Kentucky Transportation Cabinet Value Engineering Study Mountain Parkway Corridor – Construction Sequence 4

Item #10-168.00, Wolfe County

Final Value Engineering Study Report

Study Dates: March 9-13, 2015

TITLE: Realign Bedwell Road over mainline at Sta 380+00 and eliminate twin mainline bridges at KY 3034

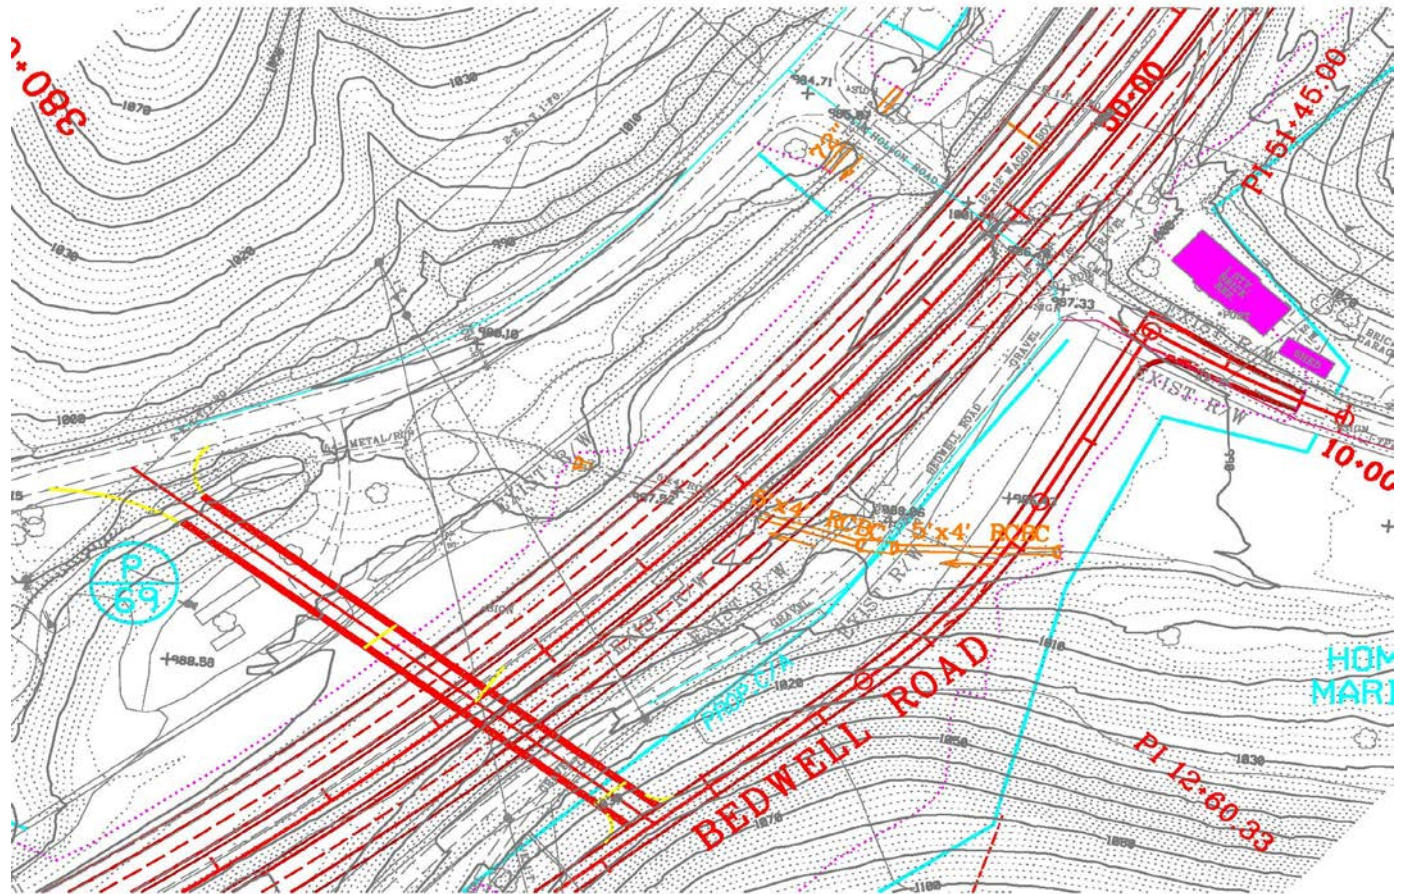
TITLE: Realign Bedwell Road over mainline at Sta 380+00 and eliminate twin mainline bridges at KY 3034																							
FUNCTION: Convey Vehicles																							
BASELINE ASSUMPTION: Twin mainline bridges are proposed over KY 3034 at station 384+80 to connect residents to KY 3033. This is the only connection for these residents as both KY 3034 and Bedwell Road dead end.																							
PROPOSED ALTERNATIVE: Connect Bedwell Road to KY 3033 at approximately Sta 16+00 (Bedwell Road) with a single bridge over the mainline instead of twin mainline bridges. Remove or safe load the existing wagon box under the mainline at Sta 384+80.																							
BENEFITS		RISKS/CHALLENGES																					
● One less bridge to build and maintain		● Profile grade of road over with vertical clearance requirement																					
● May not have to relocate the house and barn		● Will need additional right-of-way																					
● Removes 72in. pipe under KY 3034		●																					
●		●																					
●		●																					
●		●																					
●		●																					
●		●

TITLE: Consider using a 2+1 approach in lieu of 4 lanes

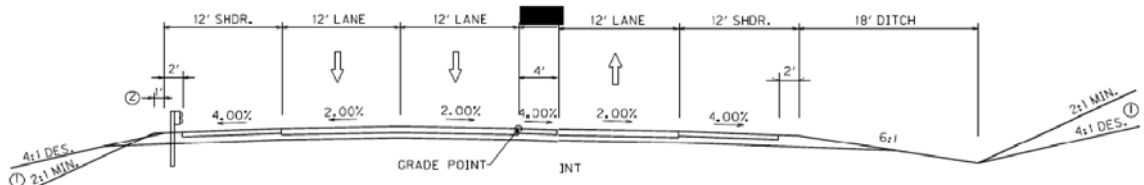
TITLE: Consider using a 2+1 approach in lieu of 4 lanes																			
FUNCTION: Convey Vehicles																			
BASELINE ASSUMPTION: Use a 4-lane typical section with a 40-foot grass median.																			
PROPOSED ALTERNATIVE: This alternative proposes to use a 2+1 typical section.																			
BENEFITS		RISKS/CHALLENGES																	
• Reduces earthwork		• No separation of traffic																	
• Revises bridge widths		• Requires legislative change to Kentucky Highway Plan																	
• Reduces pavement		•																	
• Reduces pipe extension work		•																	
• Reduces right of way acquisition		•																	
•		•																	
•		•																	
•		•

A shared four-lane highway, also known as 2+1, typically maintains a continuous three-lane cross section, and is striped in a manner to provide a passing lane in alternating directions throughout the section. This concept may be used to address operational deficiencies of two-lane highways prior to capacity being reached that would require a full four-lane highway. Shared four-lane highways have been shown to improve operational efficiency and reduce crashes over two-lane highways, and may present a cost effective alternative to four-lane divided highways.

TITLE: Extend the wagon box and eliminate the twin bridges at KY 3034

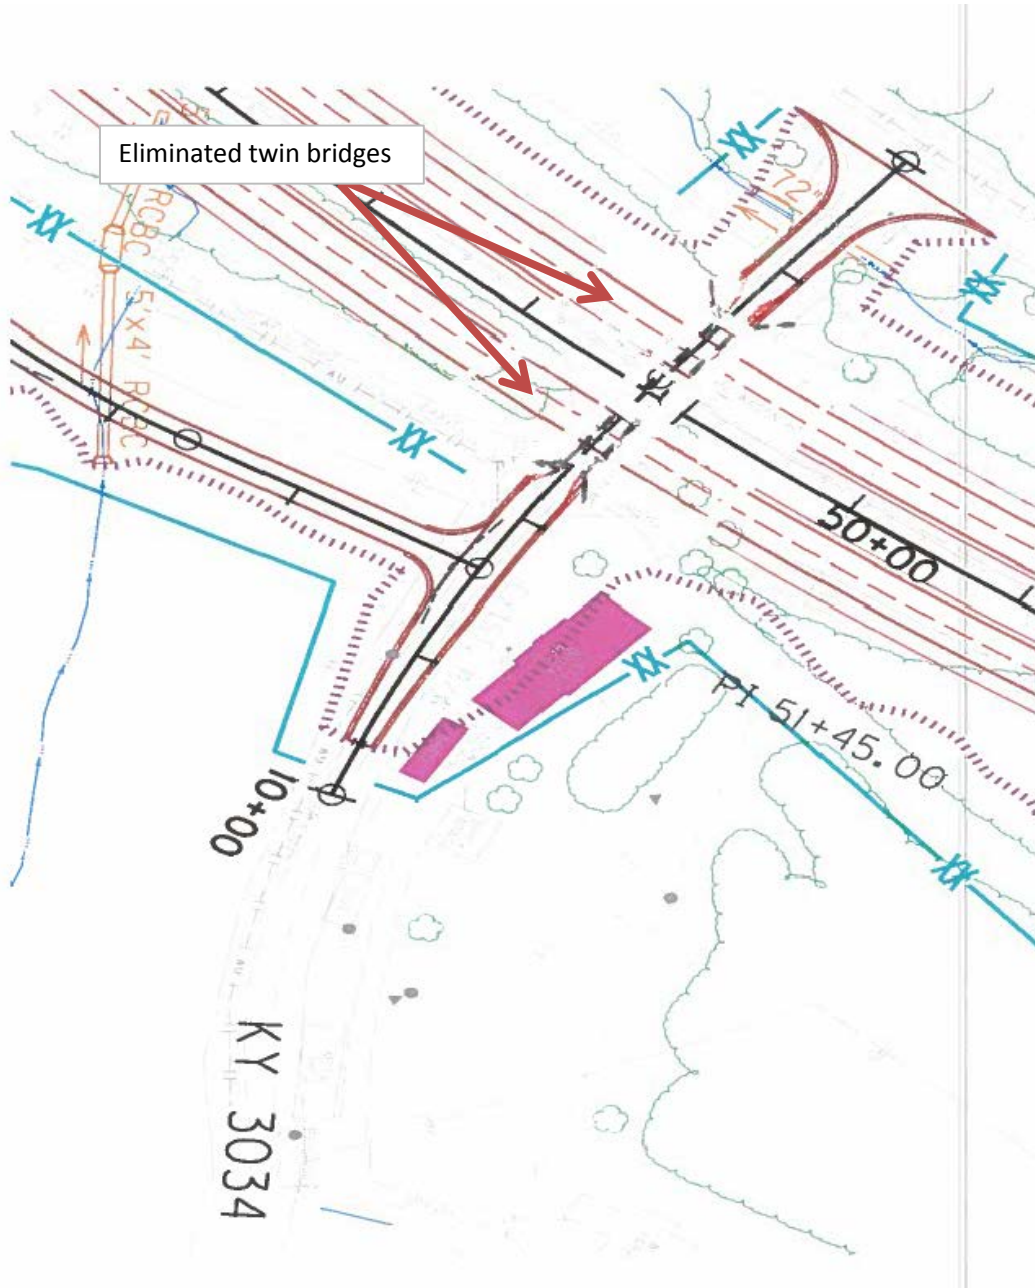
TITLE: Extend the wagon box and eliminate the twin bridges at KY 3034																							
FUNCTION: Span Space																							
BASELINE ASSUMPTION:																							
Widen KY 3034, remove the existing wagon box, and install twin bridges to carry the mainline over the widened KY 3034.																							
PROPOSED ALTERNATIVE:																							
Leave the existing wagon box in place, install a new wagon box extension, and eliminate the proposed new mainline twin bridges.																							
BENEFITS		RISKS/CHALLENGES																					
• Eliminates two bridges		• Condition of the existing wagon box																					
• Shortens construction schedule		• Local resident opposition																					
• Existing wagon box can remain in place		• Restricts movement of farm equipment																					
• Relocation of the house and barn may not be needed		•																					
•		•																					
•		•																					
•		•																					
•		•

TITLE: Extend box culvert to relocate channel change

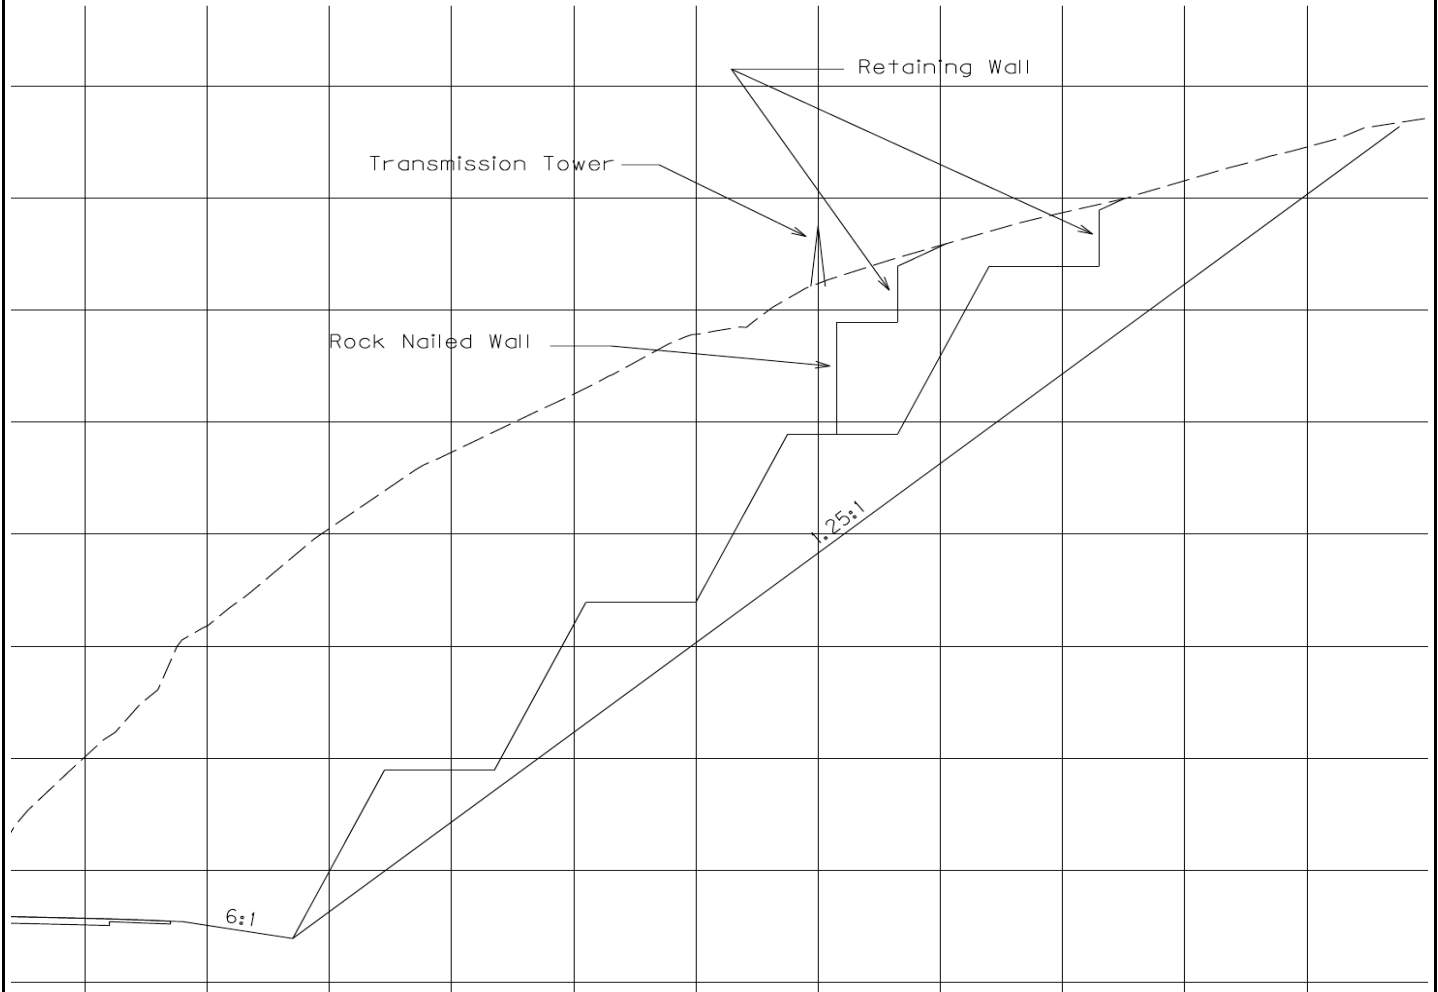
After further review, this modification will not reduce the cut slope limits enough to miss the tower which is more precisely located at station 616+50. Using .5 to 1 cut slopes (30ft. deep) combined with 18-foot benches and walls were investigated as a means to reduce the cut slope disturb limits. Two types of walls were investigated: rock nailed walls in the rock cut slopes and retaining walls to catch the overburden fill slopes. While there could be a reduction in the disturb limits, this reduction is not enough to miss the tower. **This alternative is not recommended and should be dropped from further consideration.**
